ADDENDUM NO. 1

**Project: Irrigation Improvements & Outdoor Learning Area
at A.M. Winn K-8 School**

IRRIGATION DEMOLITION PLAN
A.M. WINN ELEMENTARY SCHOOL
IRRIGATION IMPROVEMENT

AD1-1

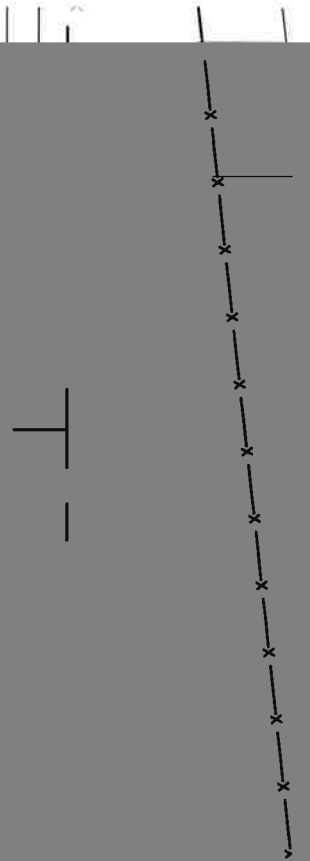
1. DRAWINGS –L1.1

These demarcations can be removed from the scope. The school district has already

DEMO CONCRETE AND FENCE FOR
EXISTING PUMP/CONTROLLER YARD

EXISTING ELECTRIC IRRIGATION
CONTROLLER TO BE REMOVED
AND REPLACED BY SPLICE BOX,
SEE IRRIGATION SHEET L2.1

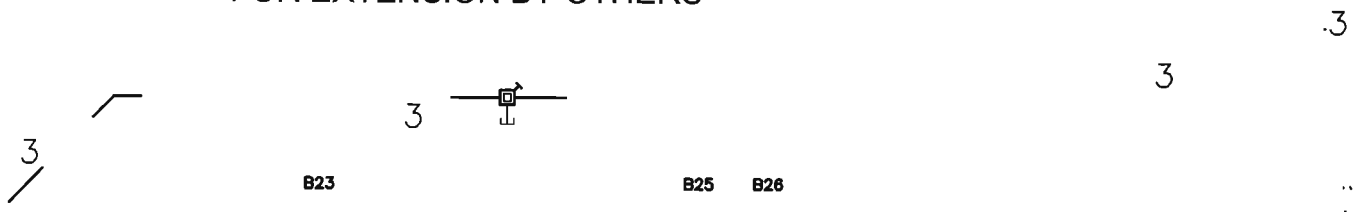
VALVES IN THIS AREA ARE TO BE
INSTALLED AND LATERAL LINE CAPPED
FOR EXTENSION BY OTHERS

ELECTRICAL WIRES FROM DEMOLISHED
IRRIGATION CONTROLLER TO BE PLACED

IN NEW SPLICE BOX AND CONNECTED TO
NEAREST NEW IRRIGATION MAINLINE
